**Sheridan City Planning Commission
Meeting Agenda
May 23, 2022
7:00 PM, City Council Chamber, City Hall**

TO: Planning Commission
FROM: Wade Sanner, Community Development Director
RE: Consideration of PL-22-6, Wellspring 2 Subdivision. The applicants, Zachary A Gray and Tatiana Popkova, are requesting to replant 14,506 square feet from 2 lots into 2 lots, zoned R-2 Residence District. Located at 624 Burton St. PIN 56842720901025.

RE: Consideration of PL-22-17, final plat of Cloud Peak Ranch 24th Filing subdivision. The applicant, Ranch at Twin Buttes LLC, is requesting to subdivide 13.23 acres of unplanted land into 57 lots and 3 outlets, zoned R-1 Residence District. Located south of Quail Ridge Rd and adjacent to Covey Run Road (PIN 56842910000100).

WELLSPRING 2 SUBDIVISION

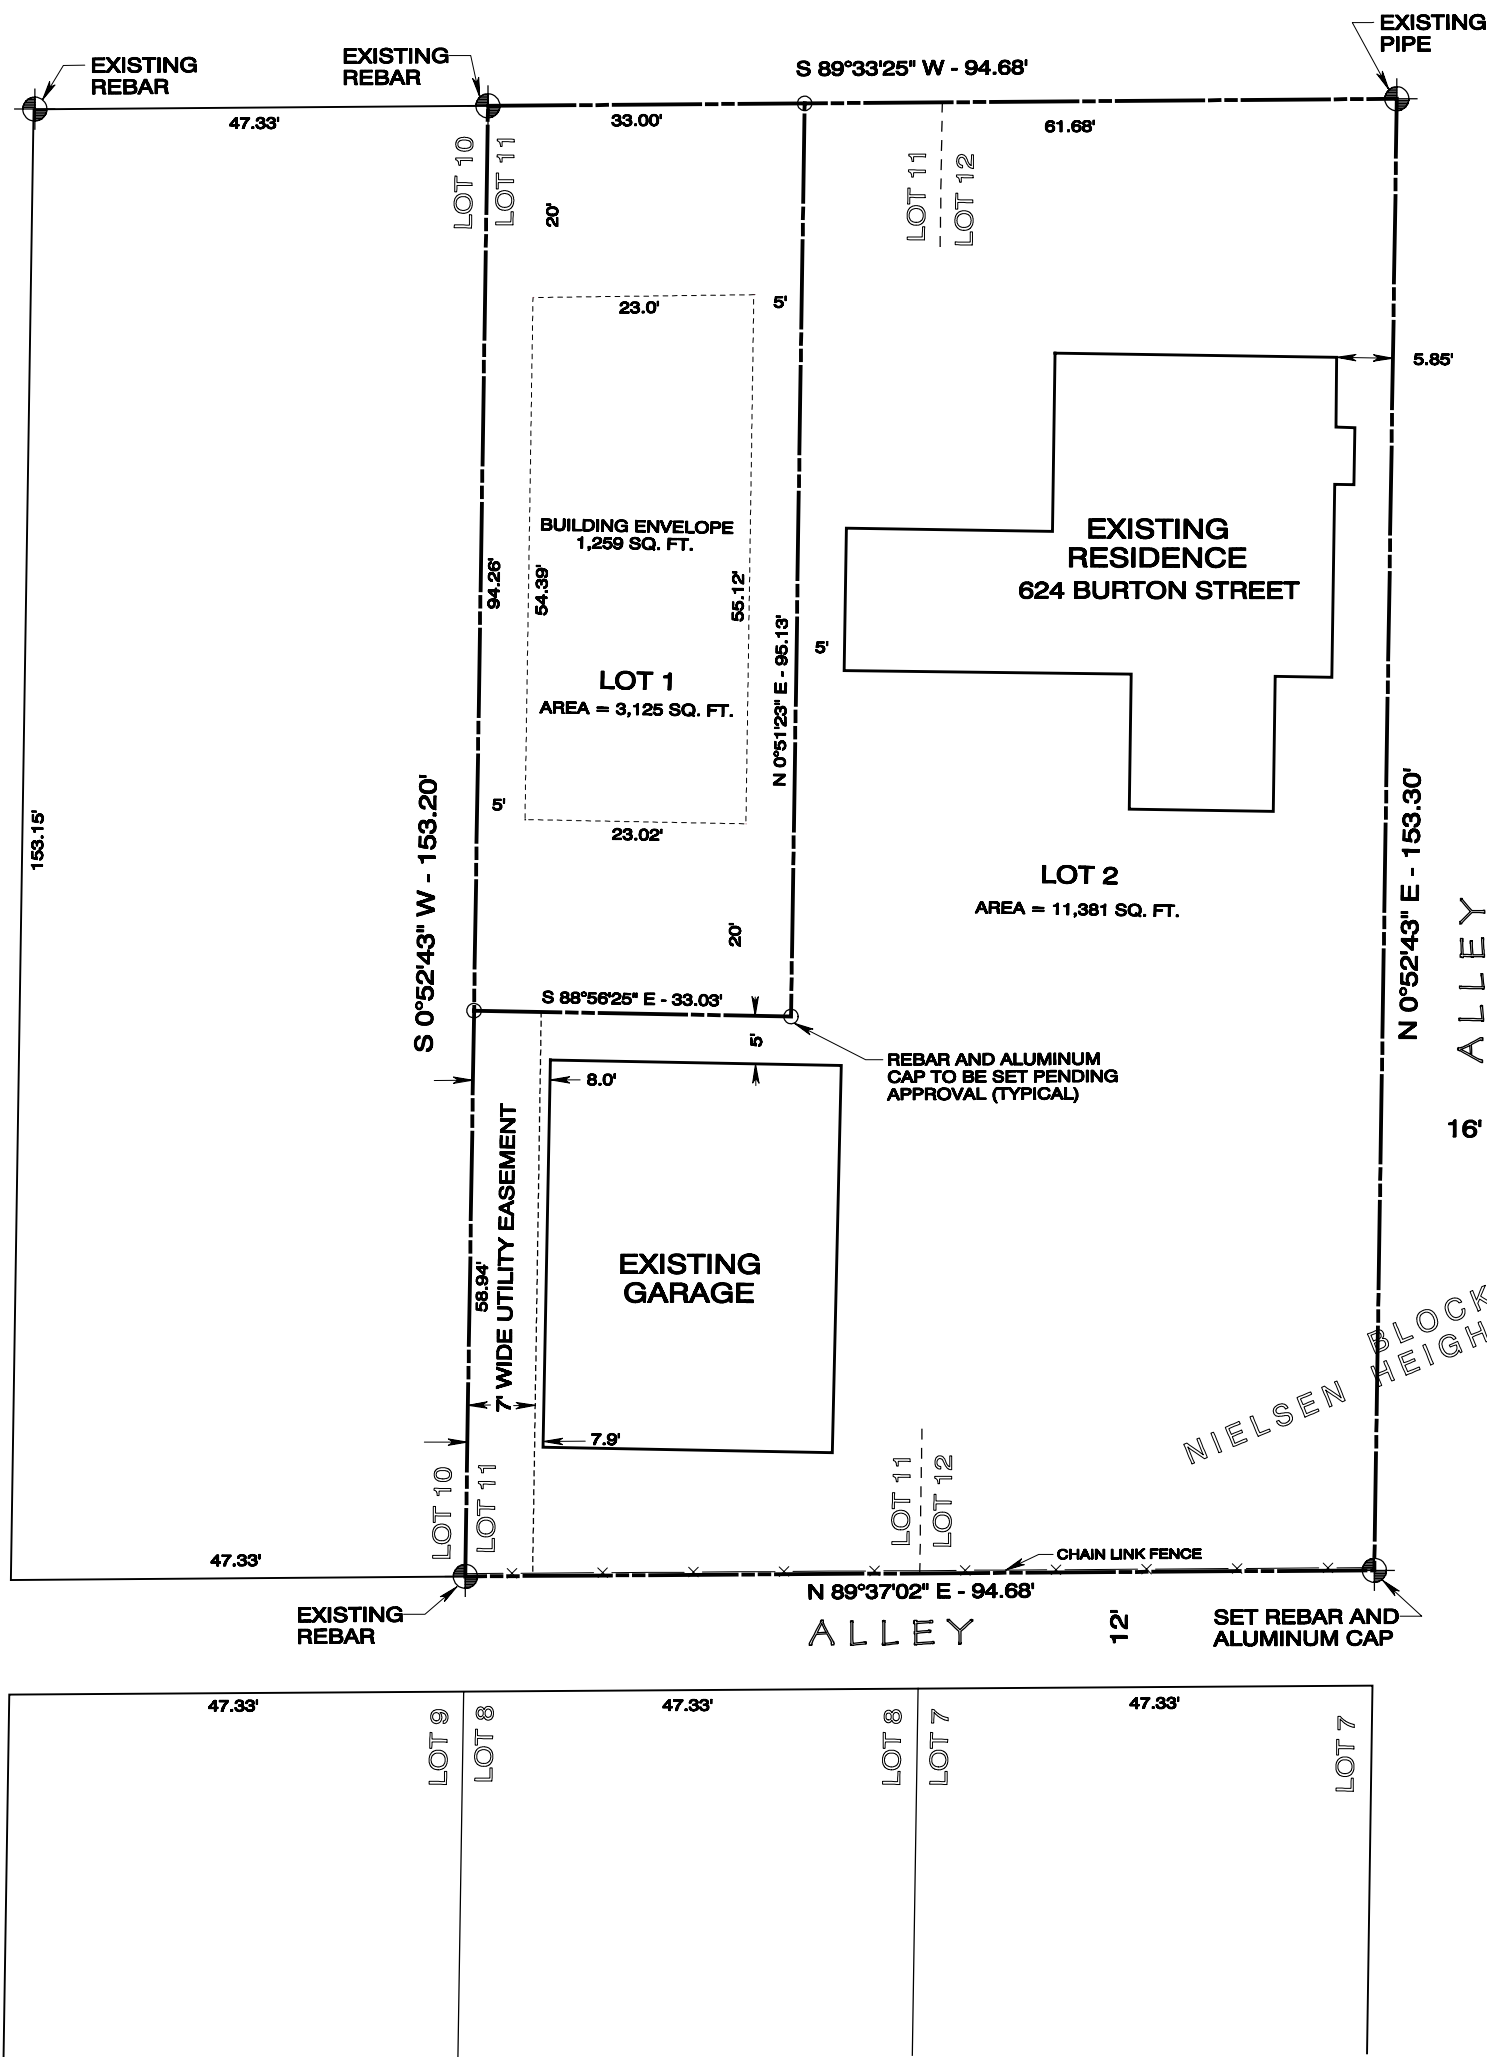
Staff recommends the Planning Commission provide a recommendation of approval to the City Council for PL-22-6, the Wellspring 2 Minor Subdivision. The applicants, Zachary Gray and Tatiana Popkova, are requesting to subdivide 0.31 (14,506 square feet) from 2 lots to 2 lots. The property is zoned R-2 Residence District, and is located at 624 Burton Street (PIN 56842720901025).

The proposed subdivision conforms to the Zoning Ordinance.

Water and sewer lines already exist in the Burton Street right-of-way. Future water and sewer connections will tap in to these lines.

The applicant is proposing to divide the property into two lots. Lot 1 is proposing to be 3,125 square feet, with a 1,259 square foot building envelope. Lot 2 is proposing to be 11,381 square feet. Lot 2 will contain the existing 1,301 square foot home and 1,200 square foot shed.

The applicant is proposing a 7-foot utility easement to run along the southwestern portion of Lot 2, between the property line and 1,200 square foot garage. This easement is a general utility easement for telephone and fiber optic lines.

The applicant is proposing to tap into the utilities to the north along Burton Street right-of-way for Lots 1 and 2.

1. The proposed Lot 1 of Wellspring 2 Subdivision has a depth to frontage ratio of 2.87:1 which is a 15% deviation from the requirements, but with current R-2 Residential Zoning requirements, still allows for a residential unit to be built while meeting all setback requirements and helps to fulfill Sheridan's need for affordable housing.

RE: Utilities in ROW

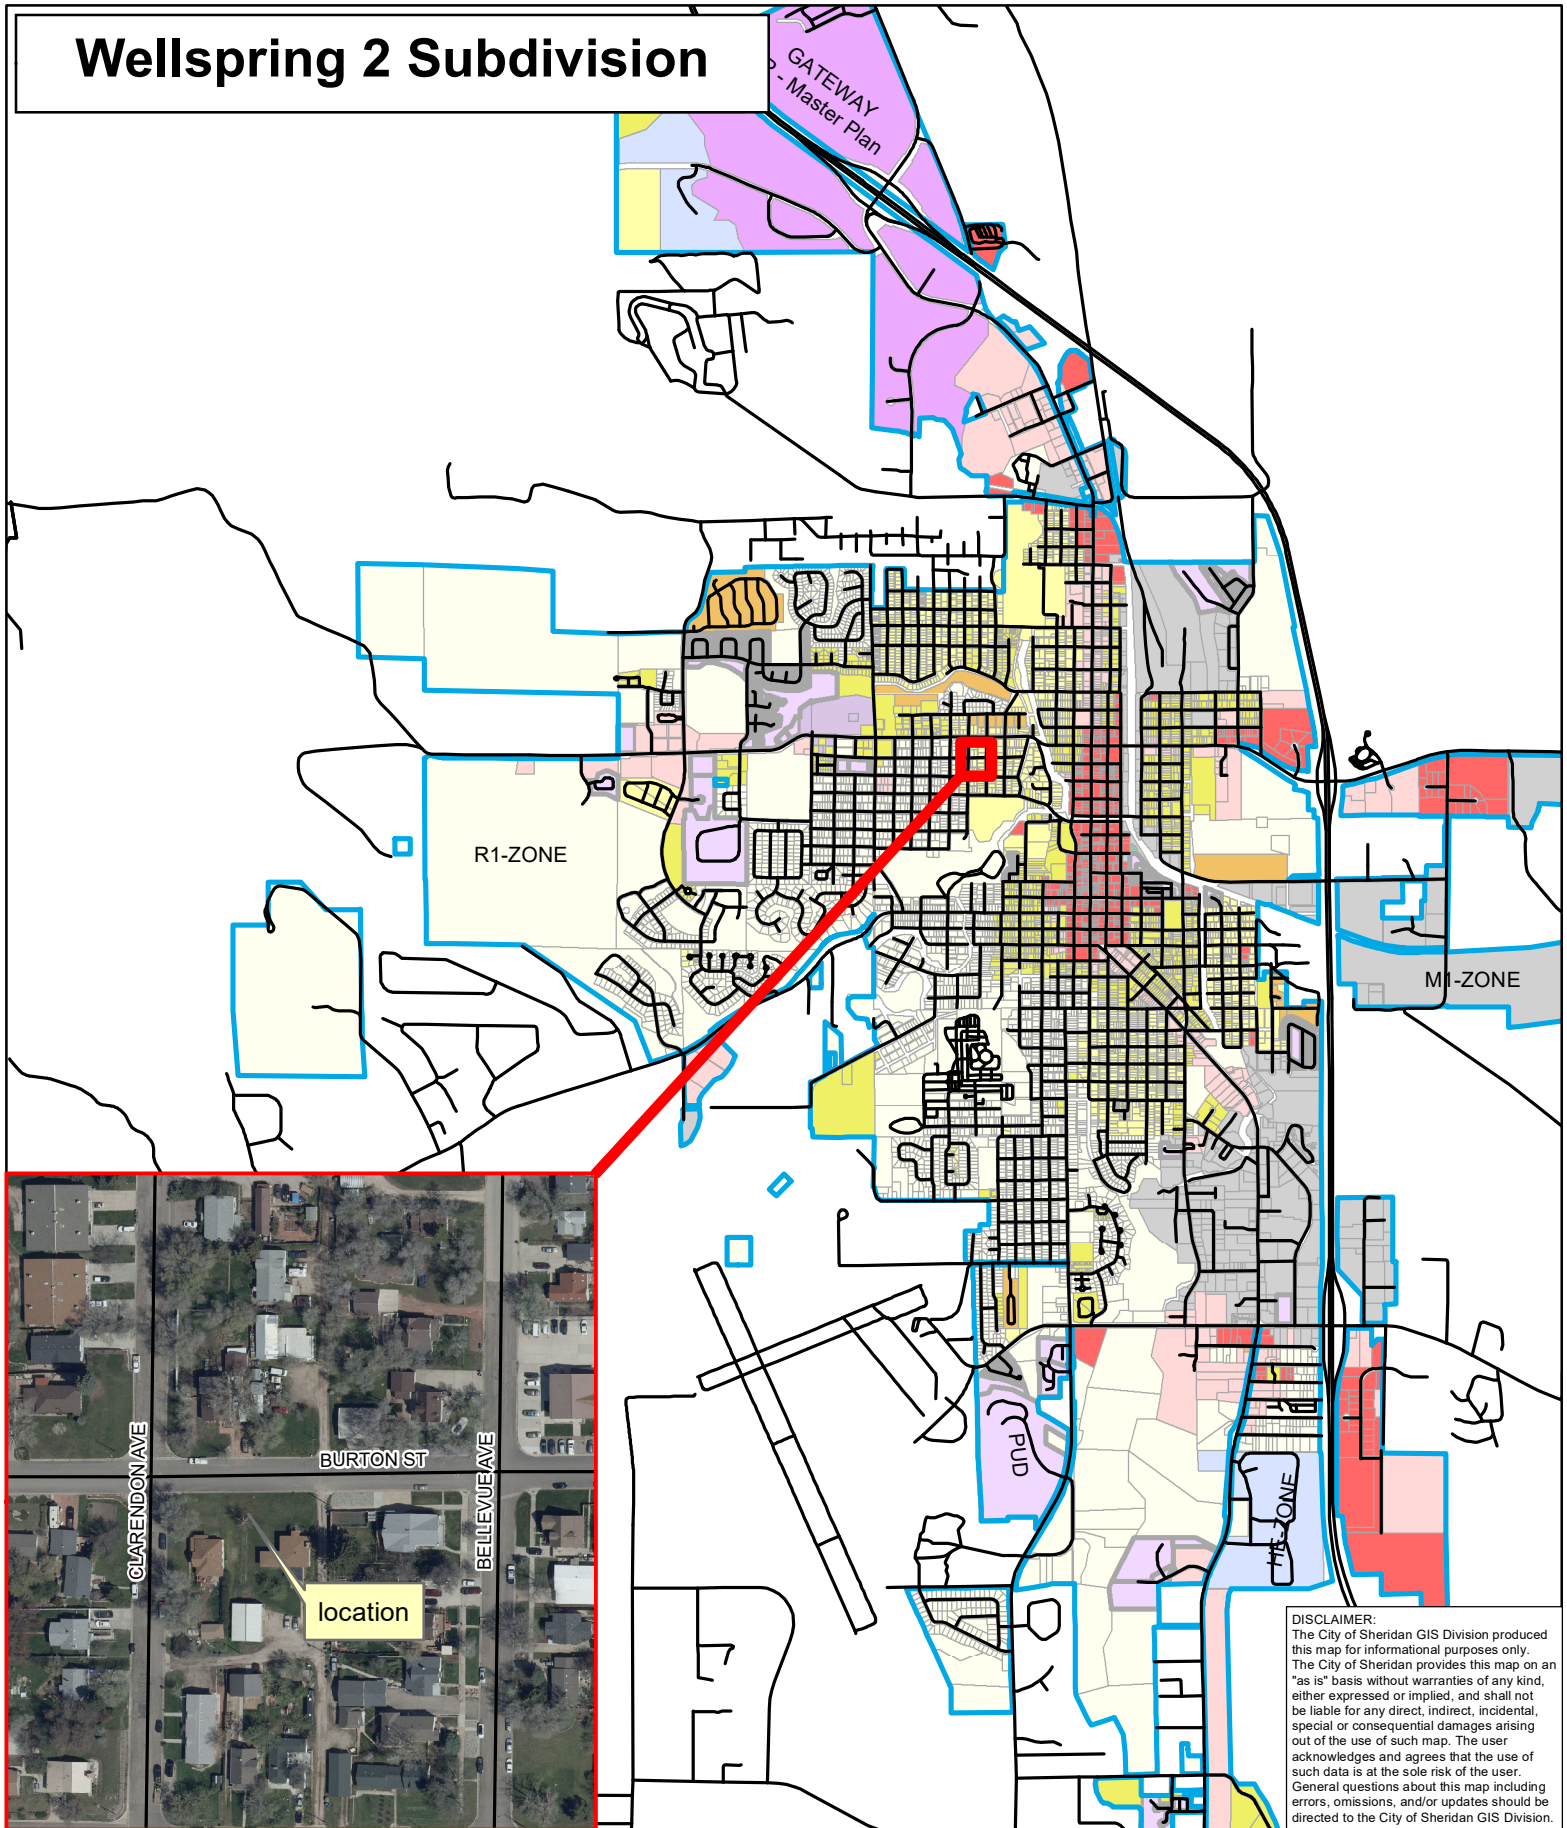
Regarding the utility installation within the ROW at 624 Burton St. and adjacent lot created by subdivision, connecting to the 20" watermain on Burton St. is not allowed. The city will authorize the installation of two water services within the City ROW from the watermain on Clarendon Ave.

SHERIDAN	CLOUD PEAK RANCH 24TH FILING	WYOMING
PROPOSED SUBDIVISION LAYOUT

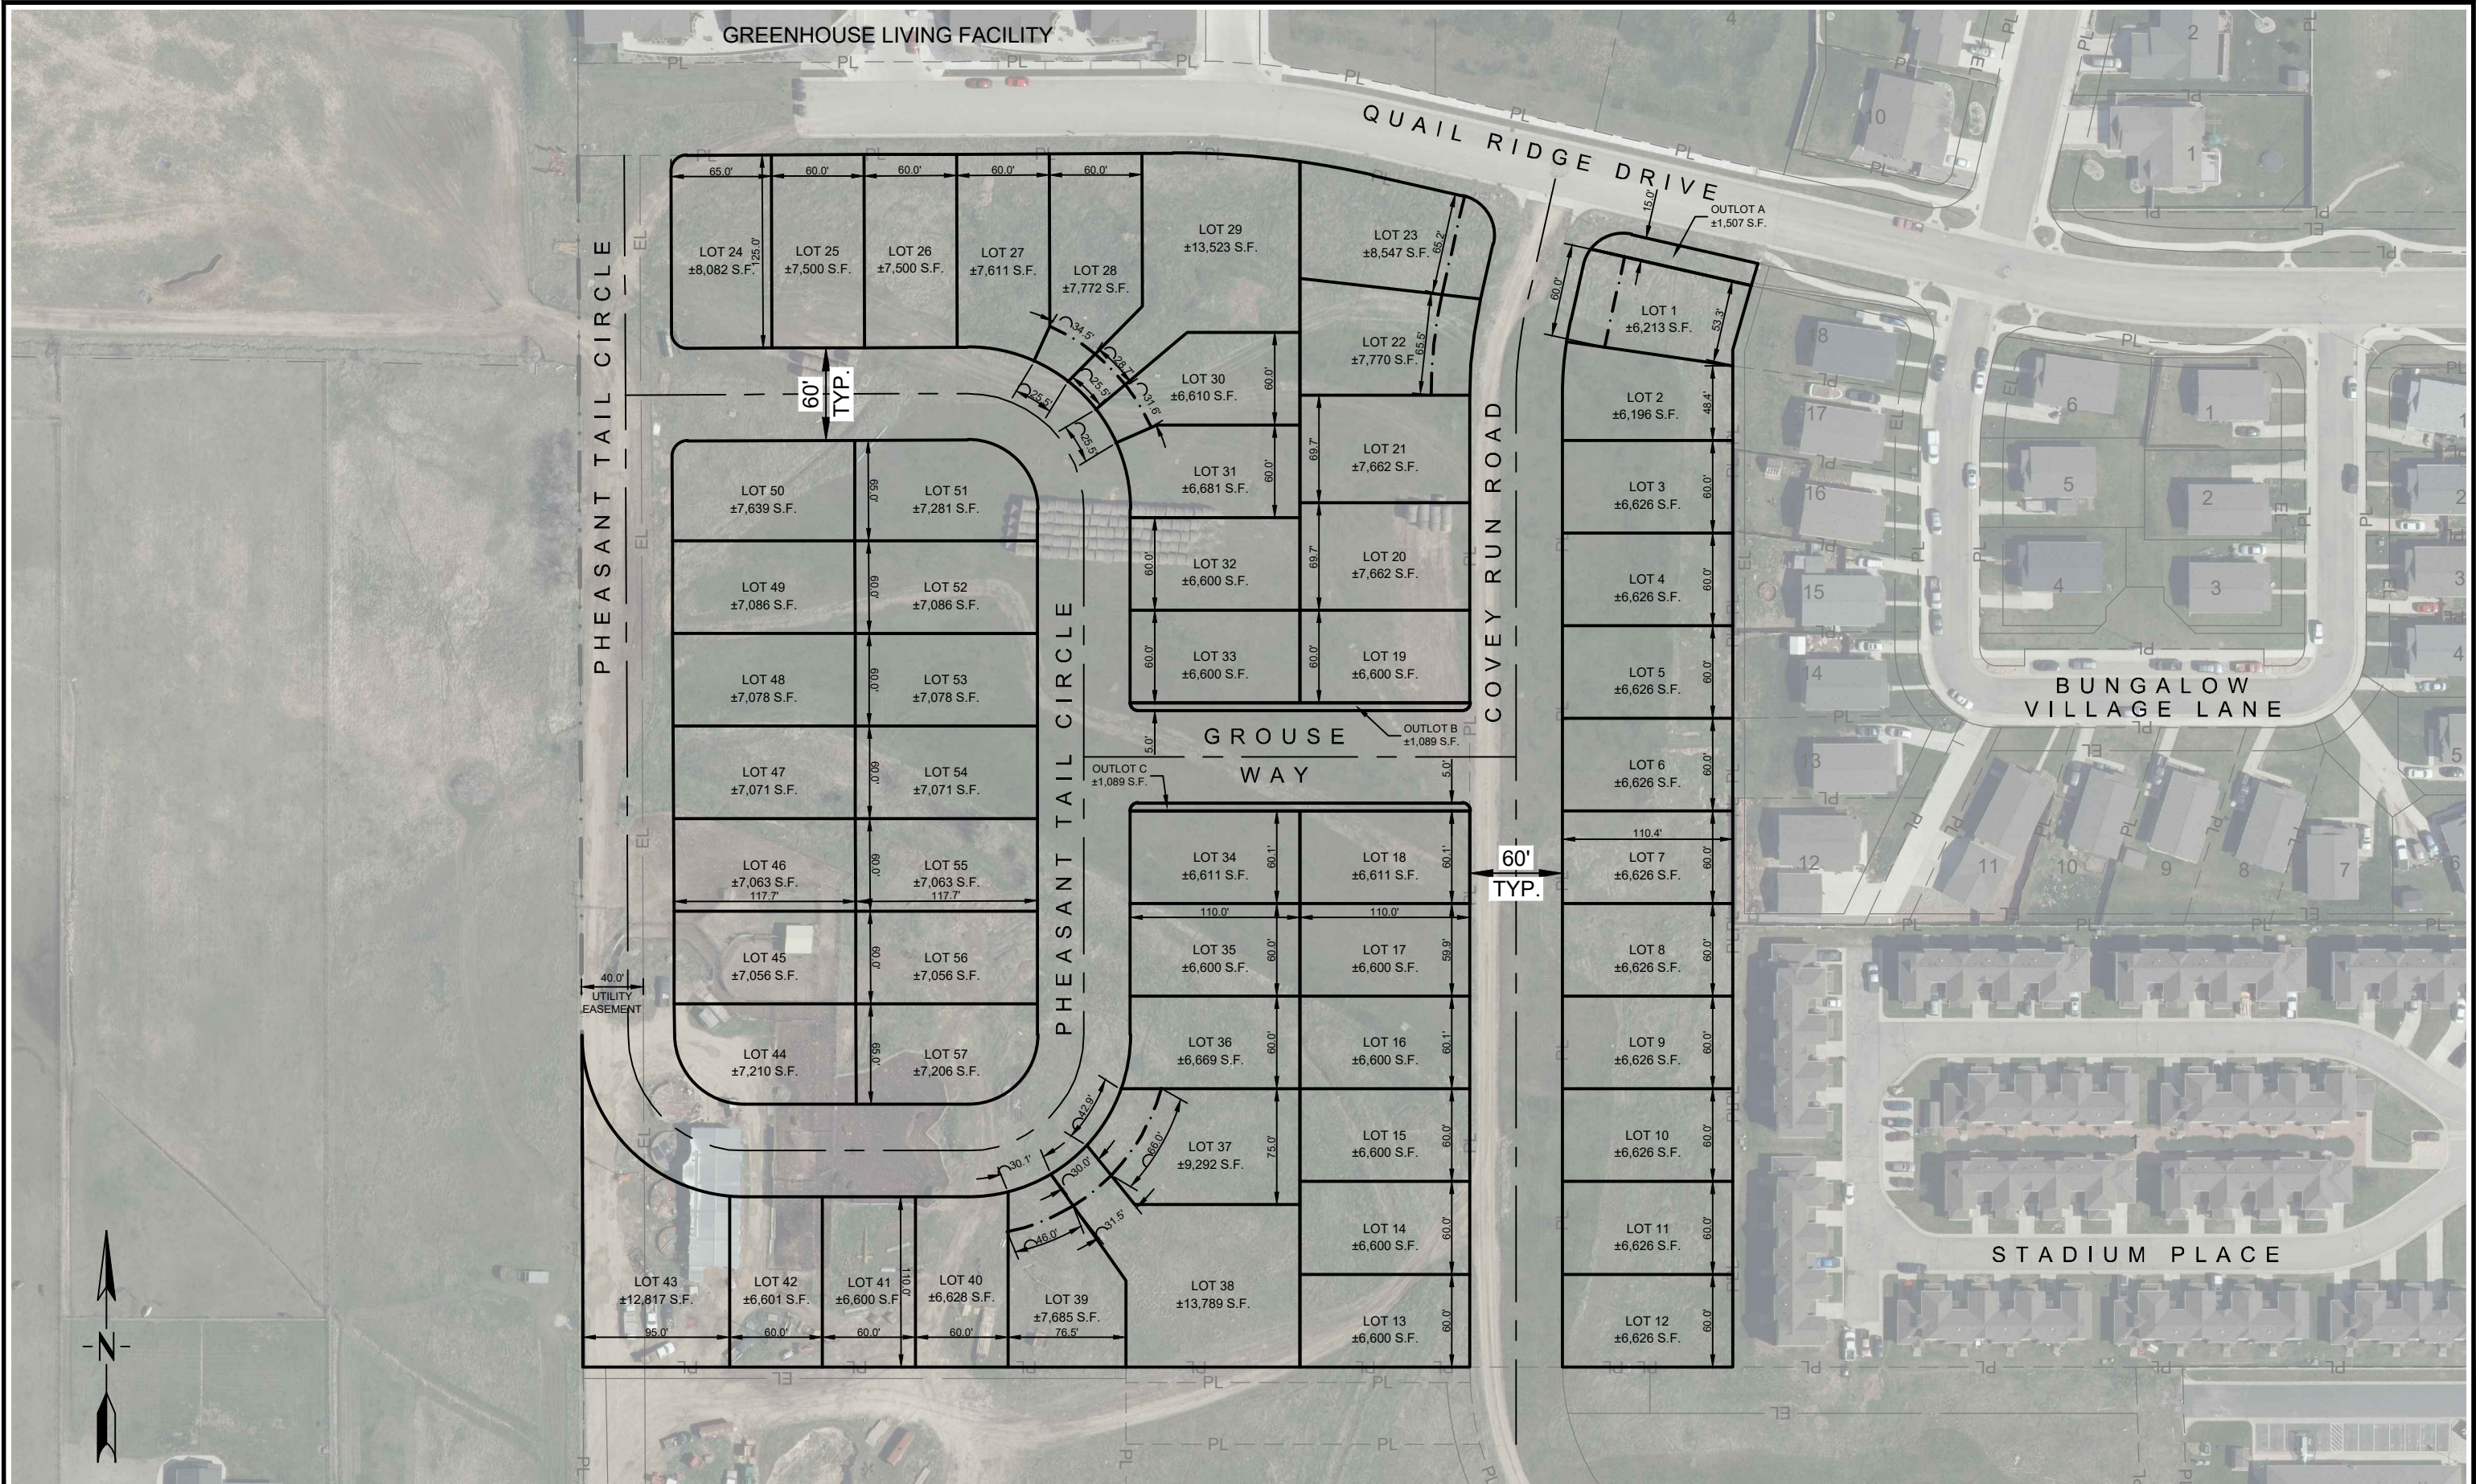
This letter constitutes a variance request for consideration by the City of Sheridan Planning Commission on the above referenced project. This variance is for depth-to-front (D:F) ratio and lot widths at the front yard setback line for six Lots (28, 29, 30, 37, 38, and 39), as shown on the enclosed drawing of Cloud Peak Ranch, 24th Filing.

Per Sheridan Municipal Code, Appendix B Subdivision Regulations, §505(C)(1), the depth-to-front ratio of lots shall not exceed 2.5 to 1. In addition, this subsection requires a minimum lot width at the building setback line of sixty (60') feet in R-1 zoning. The table below presents the actual D:F ratio and front setback width as proposed for the subdivision.

Lot #	D:F Ratio	Width at Front Setback
28	~5.49	34.5'
29	~7.25	28.7'
30	~5.10	31.6'
37	~2.98	66.0' (meets)
38	~6.00	31.6'
39	~3.92	46.0'

The shapes of these lots are unavoidable to accommodate the routing of streets and degree of curvature for the corners. We considered adding street “knuckles” at these two corners, but this does not alleviate the lot width and depth issues.

1. No undue hardship is created for the development of the six lots in question. They are in fact, larger (being corner lots), with lots 29 and 38 approximately double in size relative to other lots in the subdivision and are expected to be desirable to both buyers and builders. Corner lots with large rear yards and narrow street frontage are unavoidable.
2. The size of the lots in question will allow alternate home and garage layouts that bring interest and variability to the look and feel of the subdivision (for example, side load garages).

3. §505(C)(5) of the subdivision regulations requires that every lot shall have a frontage width and access to the public right of way with a minimum twenty-five (25') foot width. The subdivision layout was prepared to meet or exceed this requirement for all six of the lots in question.
4. We have discussed this variance request with City staff and believe it is consistent with previous approved subdivisions throughout the community.
